## Game Boy Pocket: Incompatibility board version MGB-CPU-01

## Modification to make it compatible with the kit

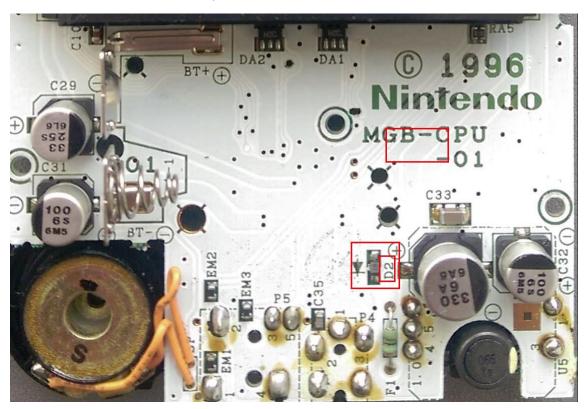
The charging kit has been designed to be compatible with the boards MGB-ECPU-01 & MGB-LCPU-02 or any other version with similar circuit. However, the GBP has many board revisions, and we know now, at least this one is not compatible: MGB-CPU-01

Not only the circuit has changed, but also the position of some electronic components:

The Diode D2 is here for the compatible boards:

But for the MGB-CPU-01 this component has been moved here:

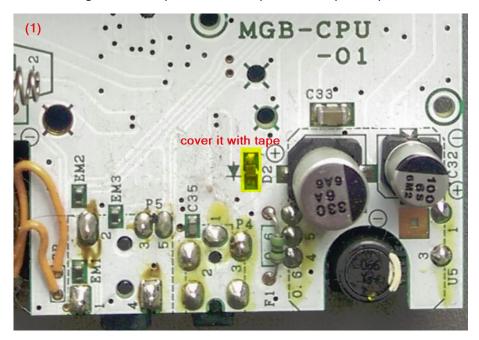
It's possible to make the board compatible with the kit, but you will need to add some extra cables.

Step 1: After removing the D2 component, ide the pads with kapton tape.
